ZONE 7 WATER AGENCY 2022-2023 STORM DAMAGE HIGH PRIORITY REPAIRS CALIFORNIA Project 307-24 ADDENDUM NO. 2 JULY 17, 2024

This Addendum No. 2 ("Addendum") is dated July 17, 2024, and modifies certain Bidding Documents issued by the Alameda County Flood Control and Water Conservation District, acting by and through its Zone 7 Water Agency ("District") in connection with the District's project: 2022-2023 Storm Damage High Priority Repairs. All capitalized terms not otherwise defined herein shall have the meanings provided in the Bidding Documents. There are no other amendments to the Bidding Documents other than expressly contained in Addendum No.1 and Addendum No. 2. The bid submission date remains unchanged.

CONTRACT DOCUMENTS AND SPECIFICATIONS					
Addendum Item	Document/ Section	Location and Description of Change			
1	Document 00010	Replace Document 00010-Table of Contents with Attachmer Document 00010A- Table of Contents. Additionally, all referencing the Contract to "Section 00010" shall refer to "Section 00010A."			
2	Document 00400	Replace Document 00400-Bid Form with Attachment Document 00400A-Bid Form. Additionally, all references in the Contract to "Section 00400" shall r

4.3

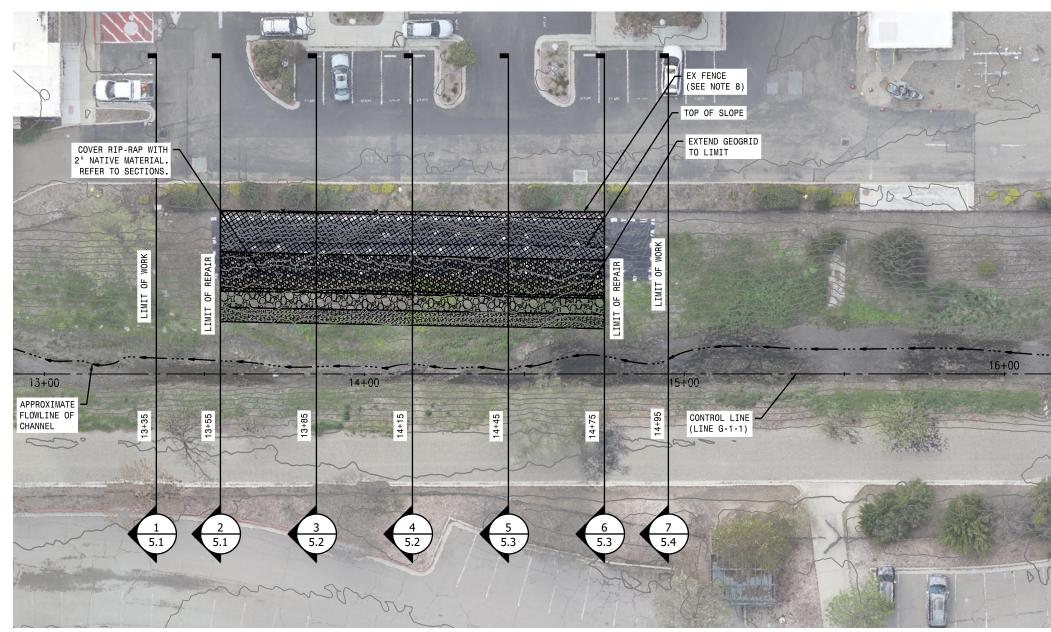
EXISTING TOP OF BANK -EX 4' CONCRETE SIDEWALK → EX 1.5 CONCRETE GUTTER TOP OF BANK EXTEND BRUSH REGRADE SLOPE TO ALLOW -MATTRESS TO DEAD STAKES AT 2' O.C. PROPER DRAINAGE, 1.75:1 ± EXISTING PAVEMENT EXISTING BENCH PROTECT EX WILLOW STAKES SPACED AT 2 0.C. TO-SECURE MATTRESS BY ACCESS ROAD 5' ABOVE ORDINARY HIGH WATER MARK LACING TWINE, ROPE, IN PLACE INSTALL SILT FENCE AT TOE OF OR WIRE IN DIAMOND SLOPE-SEE LIMITS THIS SHEET PATTERN BETWEEN STAKES. DEAD STAKES SPACED AT 2' O.C. (TO BE REMOVED AFTER CONSTRUCTION) STARTING FROM TOE AND EXTENDING TO TOP OF BANK. TOE OF BANK INSTALL BIO D-MAT 90 OR APPROVED EQUAL AT 1' DEPTH FROM 2 FEET BACK FROM HINGE 12" THICK BRUSH POINT DOWN TO TOE OF SLOPE WITHIN WILLOW STAKES AT 2' O.C. MATTRESS (WILLOW BRANCH Ŋ REPAIRED LIMITS, PER DETAIL ON SHEET FROM TOE OF SLOPE TO 5' ABOVE RIP-RAP EXISTING MIRAFI 180N CUTTINGS) 4.1. SUBGRADE SHALL BE PREPARED WITH 4" ORDINARY HIGH WATER MARK FILTER FABRIC OR -12" LIVE FASCINE BUNDLE TRENCHING FOR FIBER ROLL INSTALLATION FLOW APPROVED EQUAL--1/2 TON RIP-RAP WITH VERTICAL SPACING OF 15' MAX. BRUSH MATTRESS - PLAN VIEW LINE B - SITE 915 TYPICAL REPAIR SECTION - BRUSH MATTRESS WITH RIP RAP KEYWAY
